TOWN OF CARMEL
PLANNING BOARD

PLANNING BOARD AGENDA
OCTOBER 27, 2021 – 7:00 P.M.

Response to Richard Franzetti email of this date.

RE: Site Plan for Delamere- Fitzpatrick
87 Ellen Ave
Mahopac, NY 10541
TM #: 75.59-1-2

OWNER:	TWO LOT SUBDIVISION FRANK & ANTONIETTA FANTE 419 UNION VALLEY ROAD CARMEL (T)	SCALE:	1" = 30'	LATEST REVISION:
		DATED:	MARCH 26, 2021	SHEET No.
		TAX MAP:	87.7-1-22	S-2
FINAL SUBDIVISION PLAN

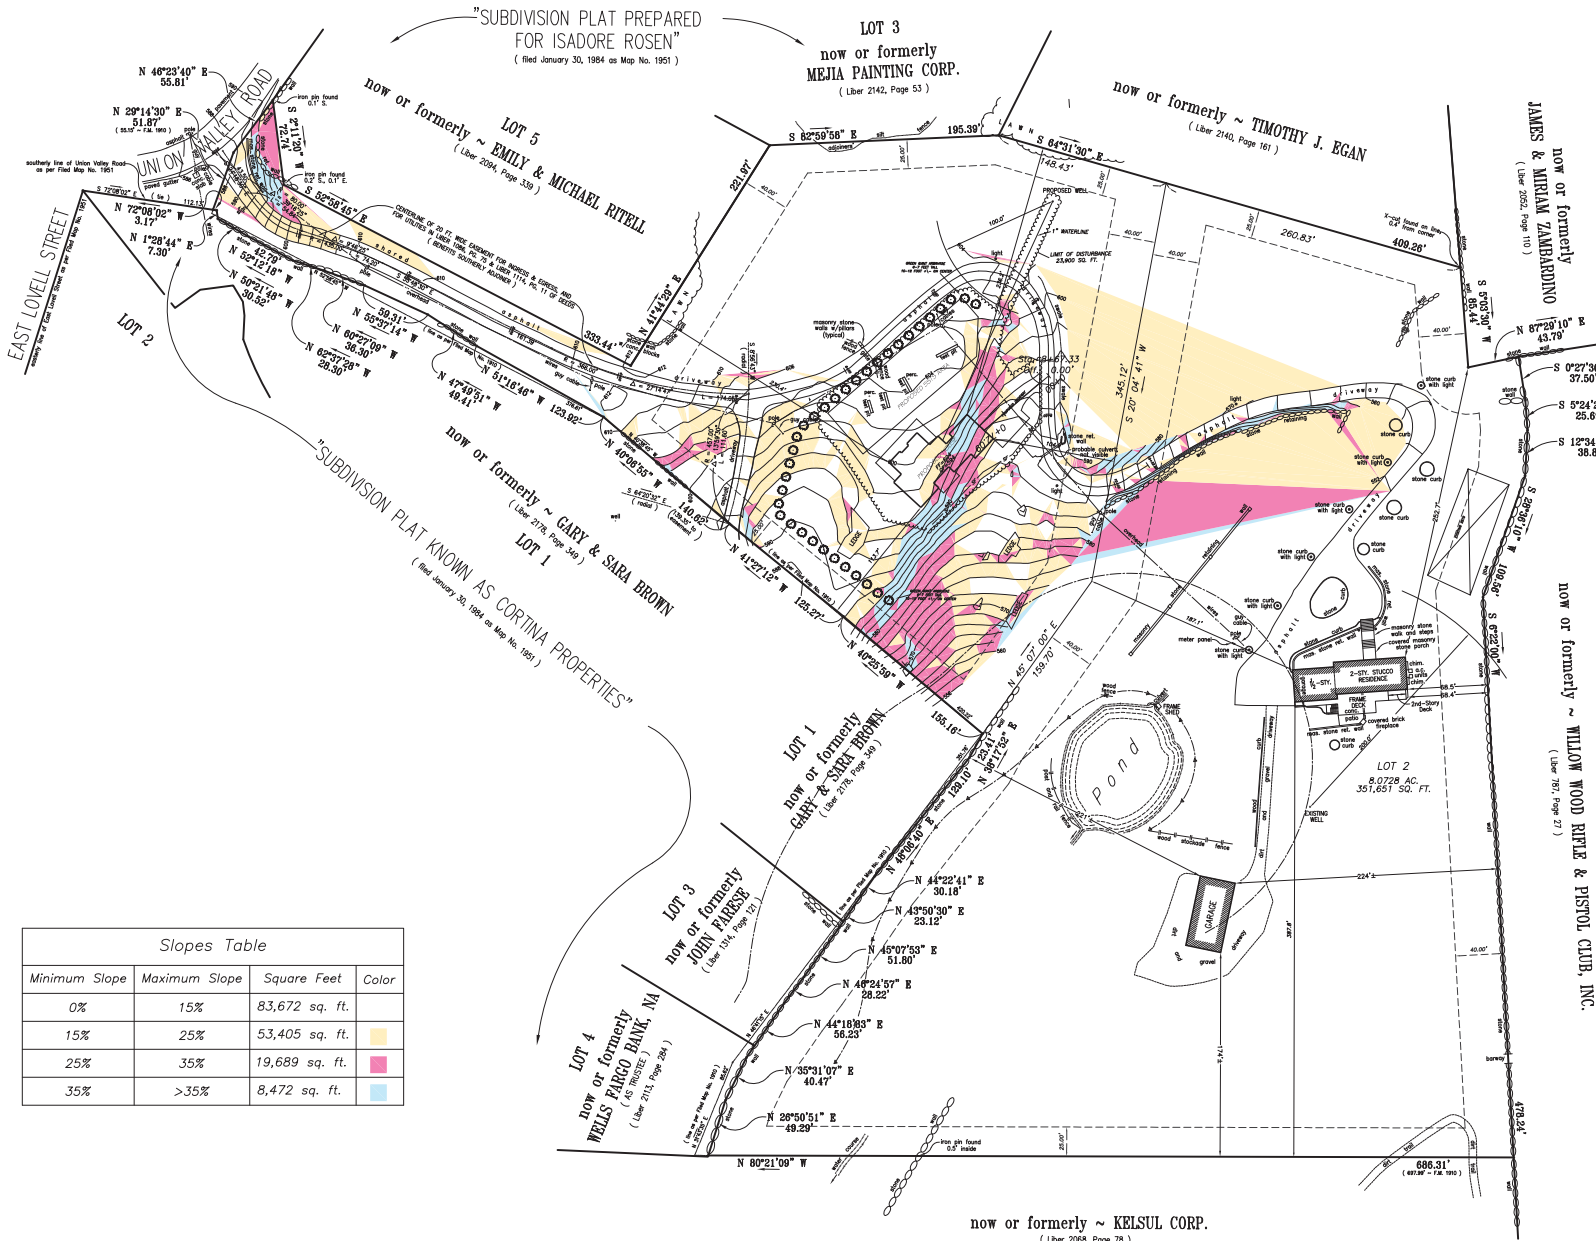
Sheet S-2 at 30 scale is the construction plan, It has been renamed for clarity Deed previously submitted.
